Re: Approval of the Final Plat of Terrell's 1st Addition, a proposed 4-lot commercial/light industrial subdivision in part of the NW¹/₄ of Section 18 in Pleasant Valley Township

STAFF REPORT

Request: Sketch Plan/Final Plat of Terrell's First Addition

FINAL PLAT OF:
TERRELL'S 1st ADDITION
 LOCATED IN THE NORTHWEST QUARTER OF SECTION
 18, TOWNSHIP 78 NORTH, RANGE 5 EAST OF THE 5TH
 PRINCIPAL MERIDIAN, SCOTT COUNTY, IOWA

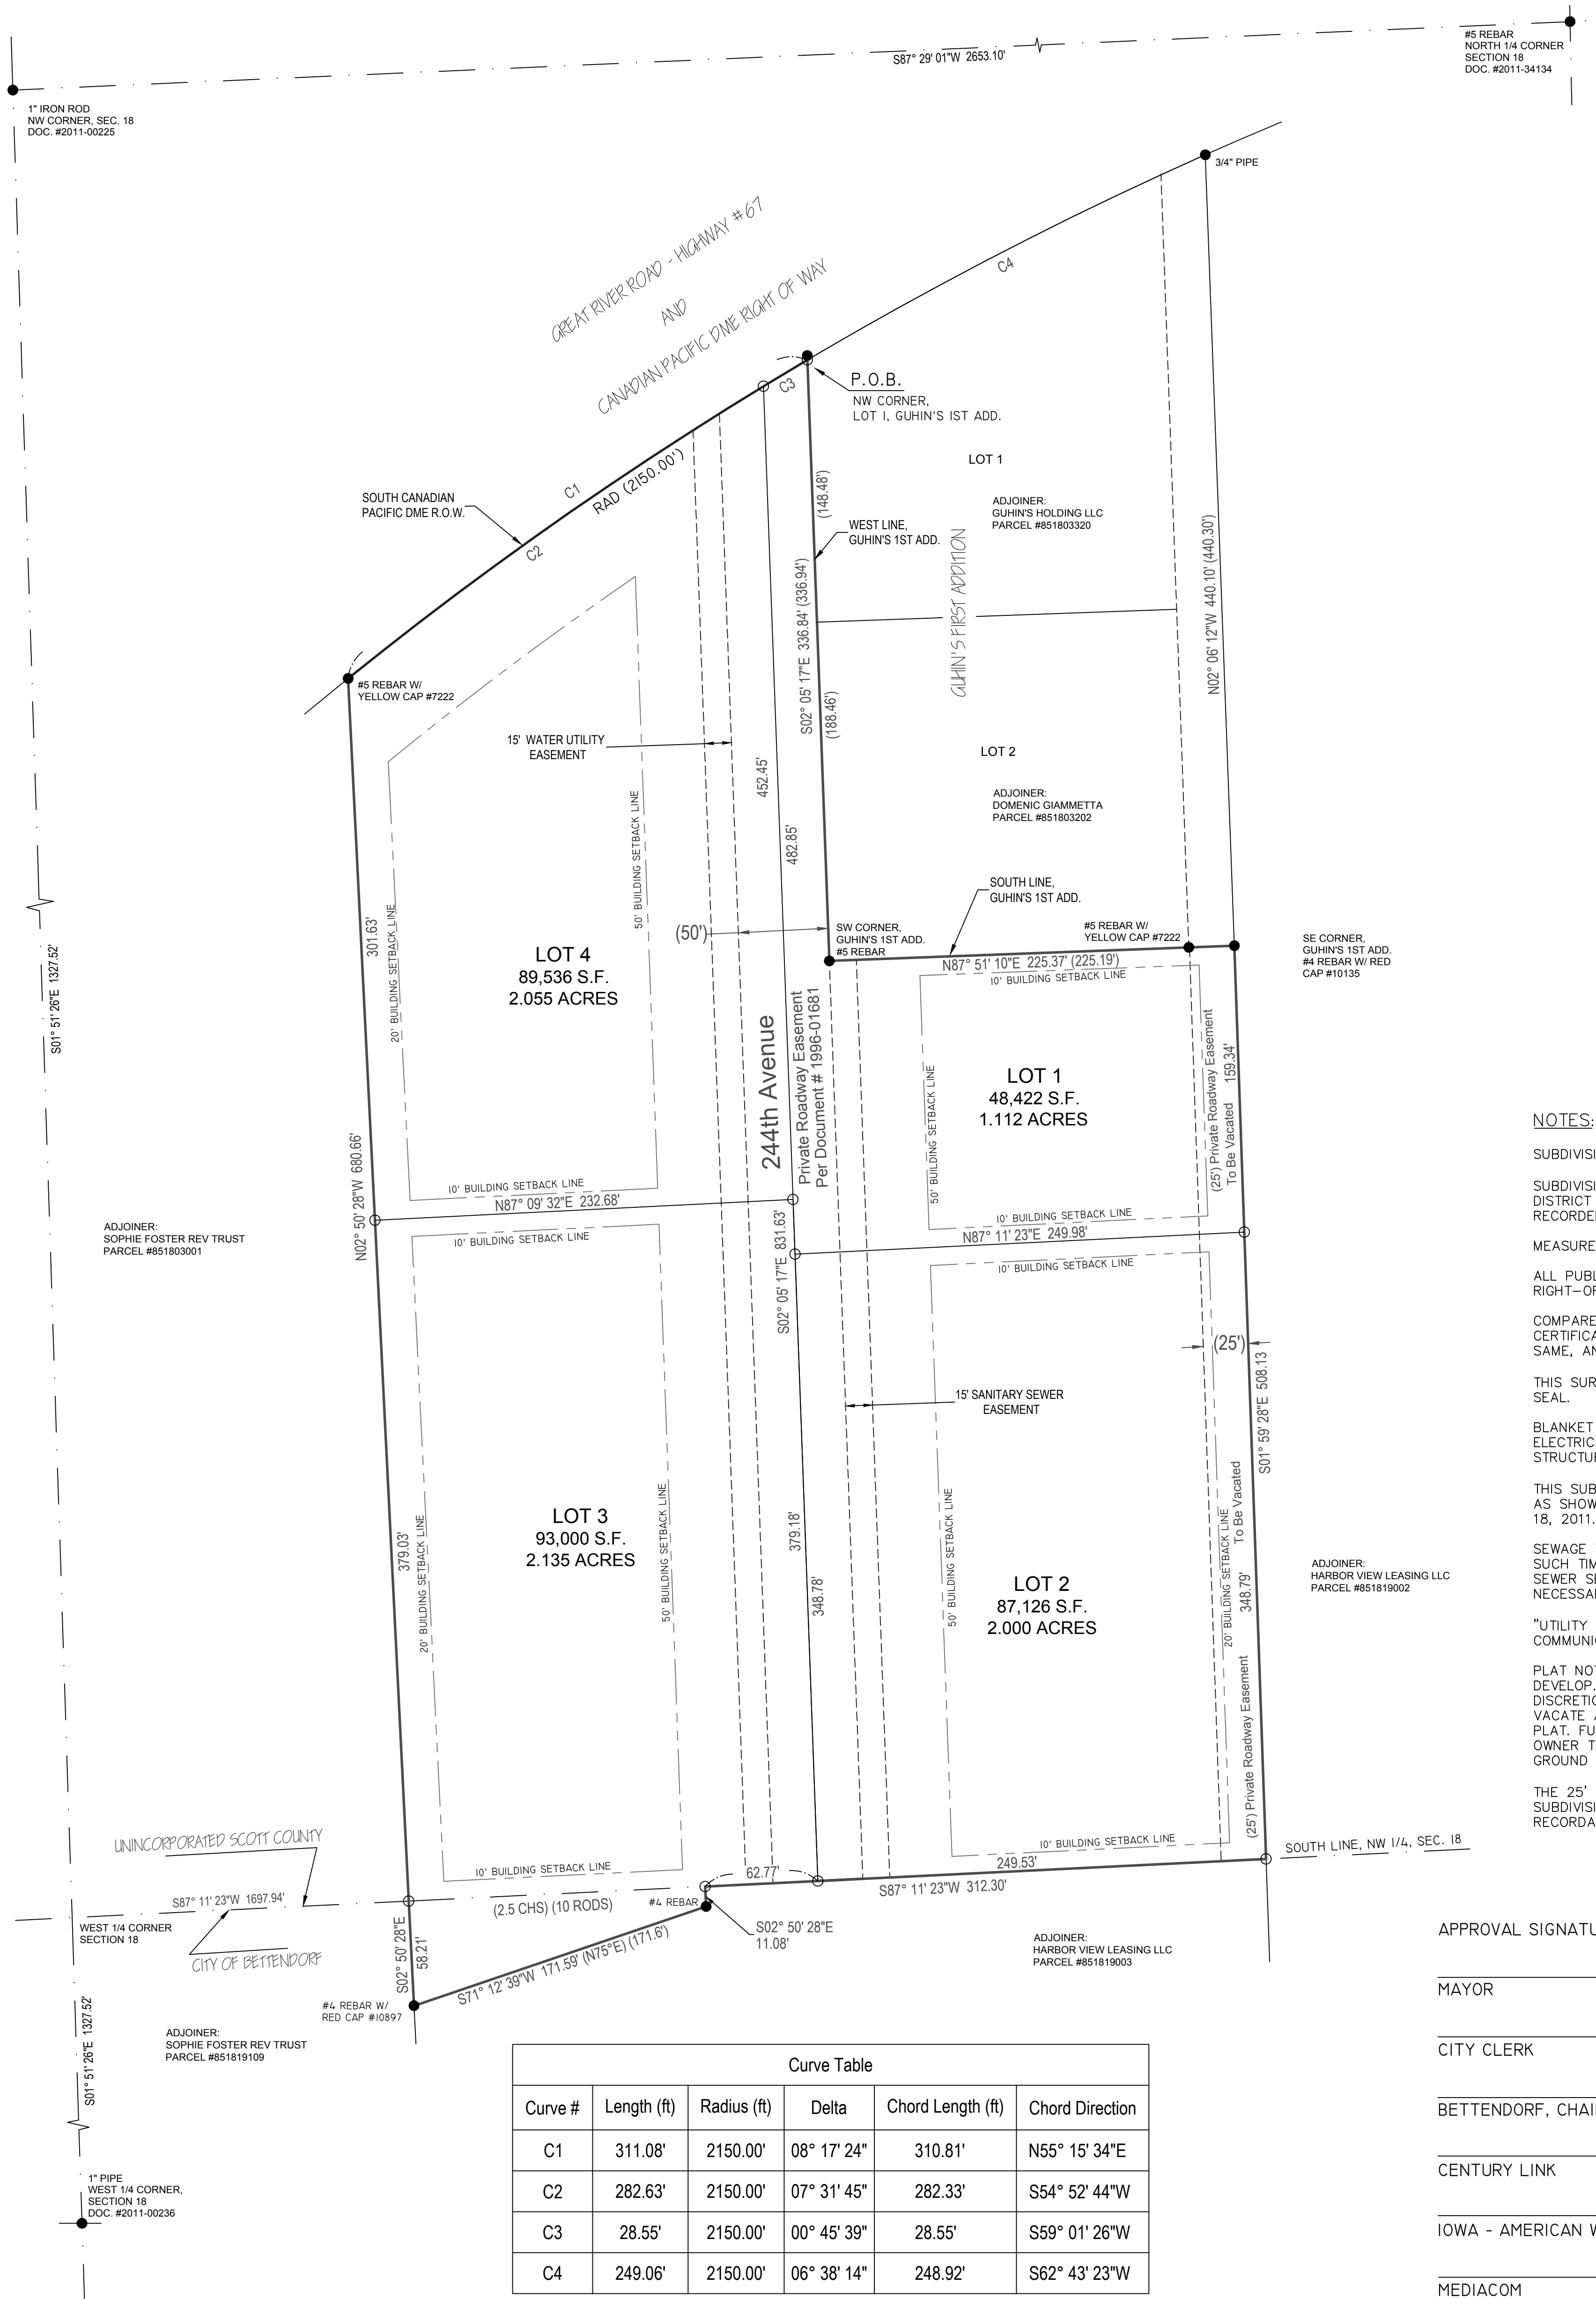
All lots would be served by 244th Avenue, a private, paved road. There is also a private roadway easement, but no roadway, on the eastern boundary of Lots 1 and 2. That private easement is labeled “To Be Vacated,” as the applicants have indicated they intend to have the easement vacated in order to expand the building envelopes on the lots. If the easement were to remain, there would be a fifty (50) foot setback from both that easement and the easement for 244th Avenue.

This property is adjacent on two sides to Bettendorf city limits. Therefore, review and approval of the Final Plat by the City of Bettendorf is required. At this time, staff and Townsend Engineering has notified the City of the Final Plat submittal but has not received formal approval/consent. The Plat will not be forwarded to the Board of Supervisors for its consideration until formal approval/consent is received.

The request includes the creation of a lot that is less than the minimum lot area requirements for a lot zoned “Commercial-Light Industrial (C-2)” with no sewer and water service. Minimum lot size for a C-2 zoned parcel without sewer and water service is 2.0 acres and Lot 1 of Terrell’s First Addition has a proposed size of approximately 1.1 acres. The applicant’s petition cites the location of a roadway easement and resulting setbacks as the exceptional situation warranting a variance. The variance request will be heard by the Zoning Board of Adjustment at its next regular meeting on June 27, 2018. Approval of the variance will be required prior to forwarding the Plat to the Board of Supervisors.

1. The City of Bettendorf approve the Final Plat
2. The Scott County Zoning Board of Adjustment approve a variance to allow the creation of a lot that is less than the minimum lot area requirements for a lot zoned “Commercial-Light Industrial (C-2)” with no sewer and water service
